## XC2300D Derivatives

16/32-Bit Single-Chip Microcontroller  
with 32-Bit Performance

Errata Sheet

V1.3 2013-09

**Figure 1 Critical application reset sequence**

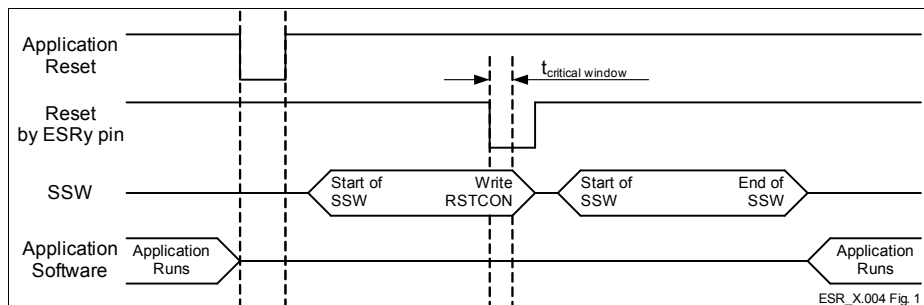
### **ESR\_X.004 Wrong Value of SCU\_RSTCONx Registers after ESRy Application Reset**

SCU\_RSTCONx registers are reset only by Power-On, but they may be wrongly affected after a second application reset requested by an ESRy pin. This may lead to the SCU\_RSTCONx register values being set to zero, which could unexpectedly disable reset sources within the user application. The conditions which lead to this behavior are:

1. First, an application reset by SW (software), CPU (Central Processing Unit), MP (Memory), WDT (Watchdog Timer) or ESRy (External Service Request y) occurs.
2. Following this, an application reset on an ESRy pin occurs.
3. If the above mentioned ESRy reset occurs during a critical time window of the SSW (startup software), then it's possible that the application will operate with the wrong SCU\_RSTCONx register value. The critical time window occurs when the SSW is writing the SCU\_RSTCONx registers, and at the same time, the ESRy reset request is processed by the reset circuitry. The width of this critical window  $f_{\text{critical window}}$  is less than 13 cycles.

- Initialize `SCU_RSTCONx` registers by user software after any reset, or
- assure that a second application reset request with an ESR pin does not occur during the critical time window.

**Figure 2 Alert Interrupt Behavior in case of Bus-Off**

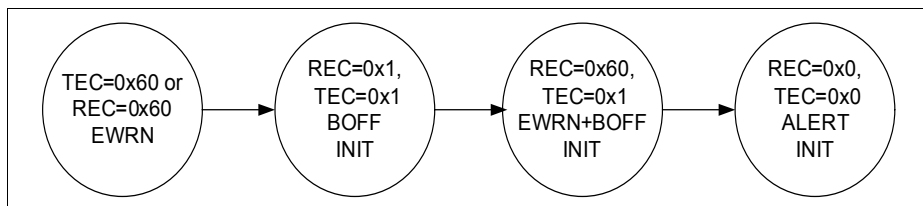
### **MultiCAN\_AI.H007 Alert Interrupt Behavior in case of Bus-Off**

The MultiCAN module shows the following behavior in case of a bus-off status:

When the threshold for error warning (EWRN) is reached (default value of Error Warning Level EWRN = 0x60), then the EWRN interrupt is issued. The bus-off (BOFF) status is reached if  $TEC > 255$  according to CAN specification, changing the MultiCAN module with REC and TEC to the same value 0x1, setting the INIT bit to 1<sub>B</sub>, and issuing the BOFF interrupt. The bus-off recovery phase starts automatically. Every time an idle time is seen, REC is incremented. If REC = 0x60, a combined status EWRN+BOFF is reached. The corresponding interrupt can also be seen as a pre-warning interrupt, that the bus-off recovery phase will be finished soon. When the bus-off recovery phase has finished (128 times idle time have been seen on the bus), EWRN and BOFF are cleared, the ALERT interrupt bit is set and the INIT bit is still set.

**Figure 3 Loss of Arbitration**

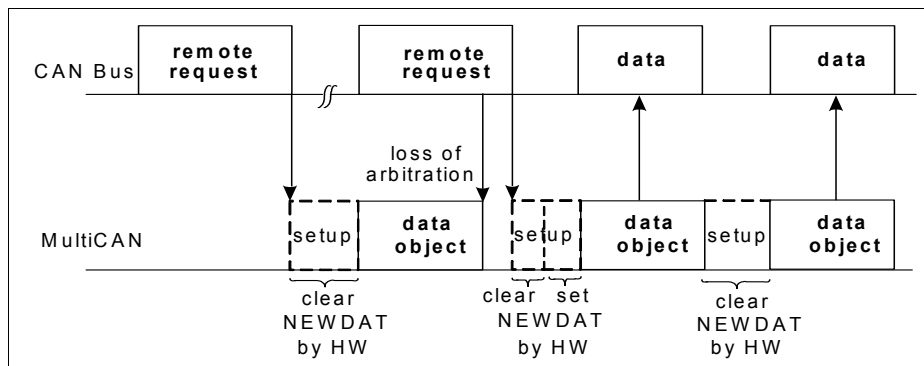
When the appropriate message object (data frame) triggered by the first remote frame wins the arbitration, it will be sent out and `NEWDAT` is not reset. This leads to an additional data frame, that will be sent by this message object (clearing `NEWDAT`).

There will, however, not be more data frames than there are corresponding remote requests.
